# Memorandum to the City of Markham Committee of Adjustment

**File:** A/086/20  
**Address:** 6 Sherwood Forest Drive – Markham, ON  
**Applicant:** Qi Zhou  
**Agent:** Prohome Consulting Inc.  
**Hearing Date:** Wednesday November 18, 2020

The applicant is requesting relief from the following requirements of the “Residential (R2)” zone under By-law 1229, as amended (“the By-law”), as it relates to a proposed two-storey detached dwelling, to permit:

# Appendix IV: Tree Preservation Plan

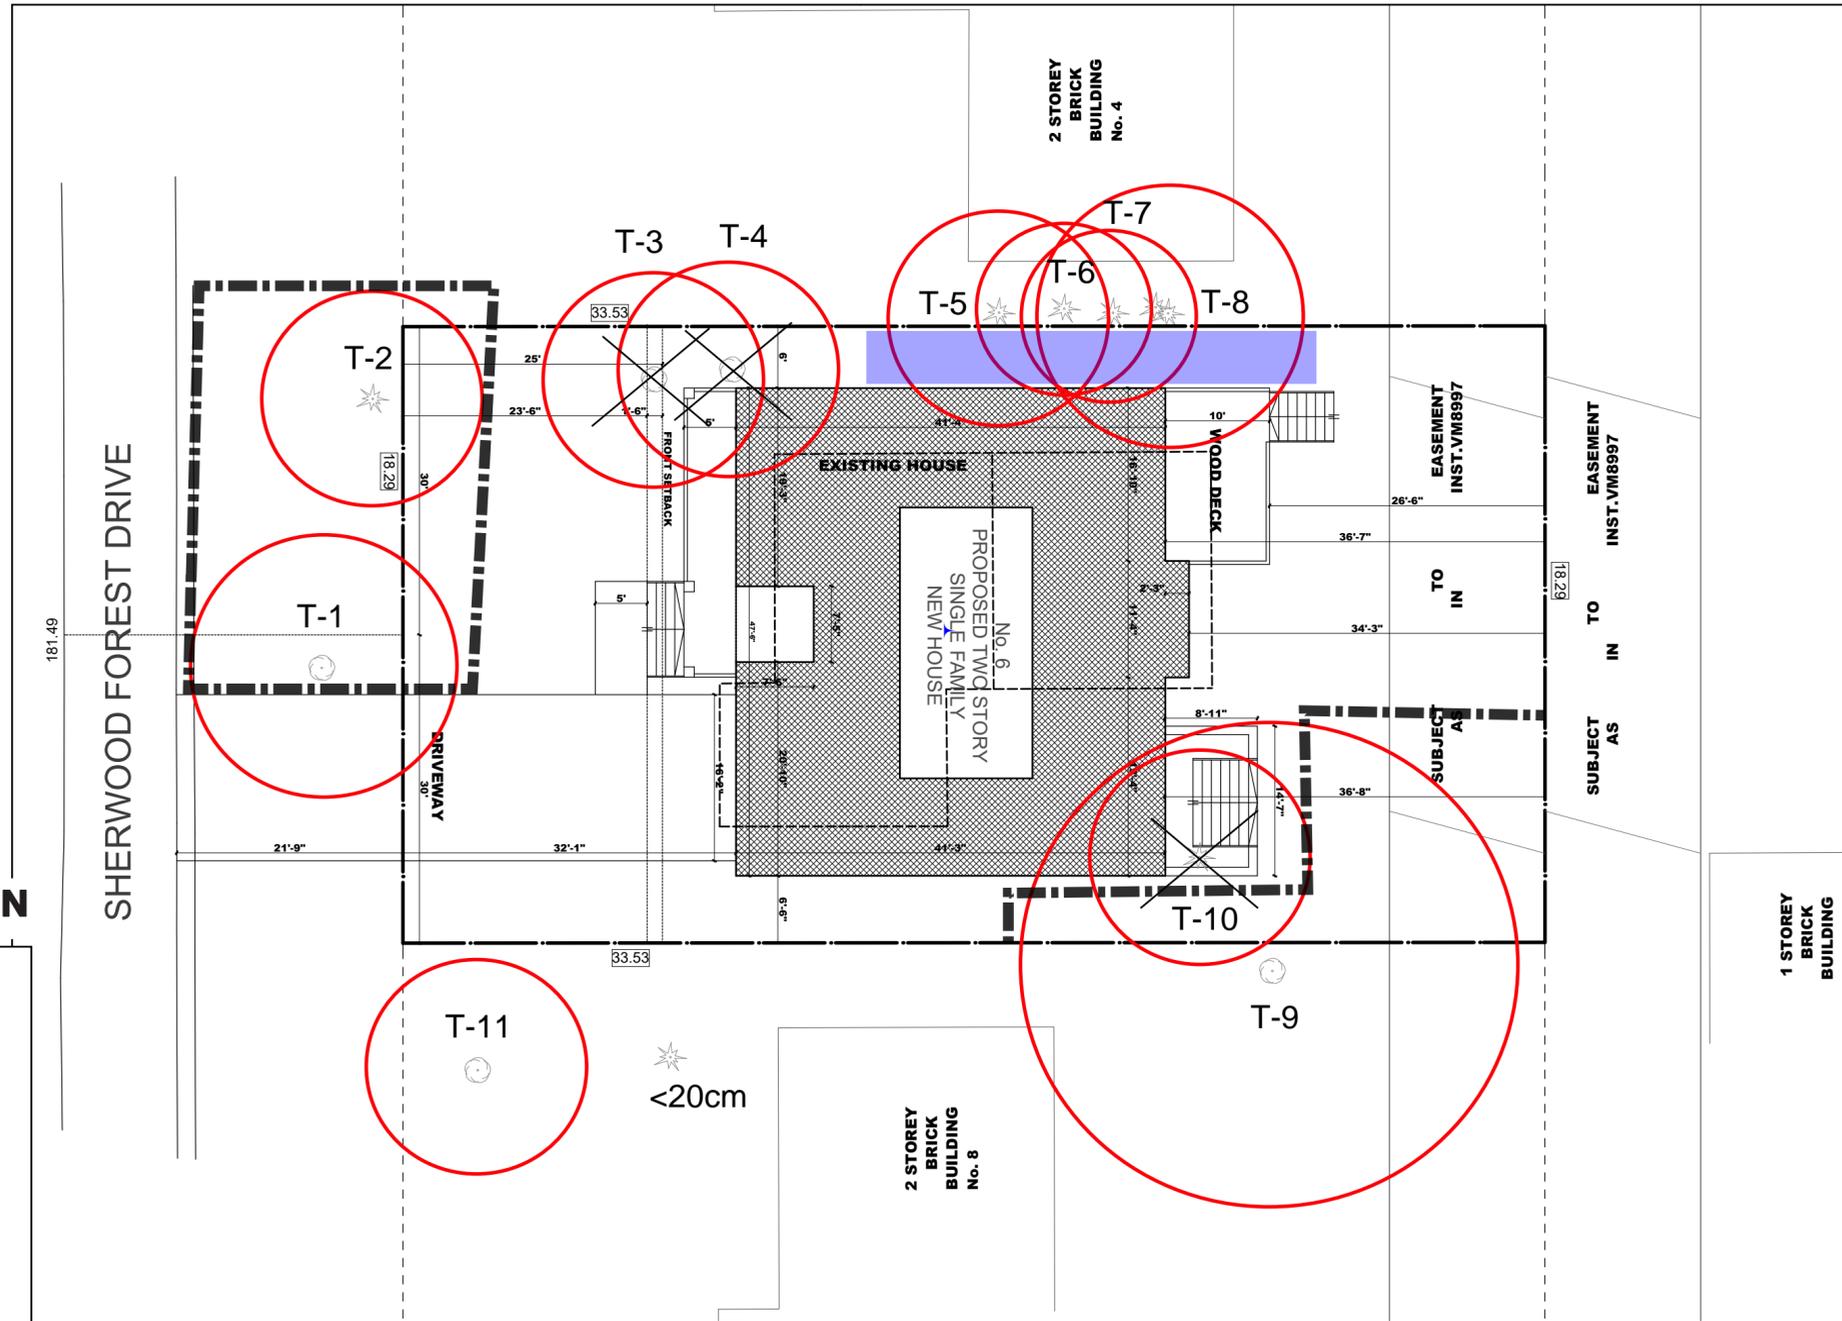
The applicant submitted an arborist report and tree preservation plan which proposes to maintain one of the City owned trees (Tree #2) located in the municipal boulevard, and proposes to injure the other City owned tree (Tree #1) due to the location and width of the driveway (see Tree Preservation Plan, Appendix “C”). The submitted arborist report also

Urban Forestry staff expressed a specific concern with potential impacts to Tree #9 from the location of a proposed basement walkout on the subject property. Tree #9 is a mature Sugar Maple tree in the rear yard of the neighbouring property to the west, assessed as being good condition. In response, the applicant revised their plans (Appendix "B") to relocate the basement walkout further away from this tree. Urban Forestry staff are satisfied with this change. Staff recommend that all trees be subject to the tree conditions provided in Appendix "A" in the event of any approval.

3. That the Arborist Report and Tree Assessment and Preservation Plan, prepared by a qualified arborist in accordance with the City's Streetscape Manual (2009), as amended, be updated to reflect the changes made in accordance with the revised batch stamped plans attached as Appendix "B", and that it be reviewed and approved by the City, and that the Secretary-Treasurer receive written confirmation from the Tree Preservation Technician or Director of Operations that this condition has been fulfilled to his or her satisfaction, and that any detailed Siting, Lot Grading and Servicing Plan required as a condition of approval reflects the Tree Assessment and Preservation Plan.
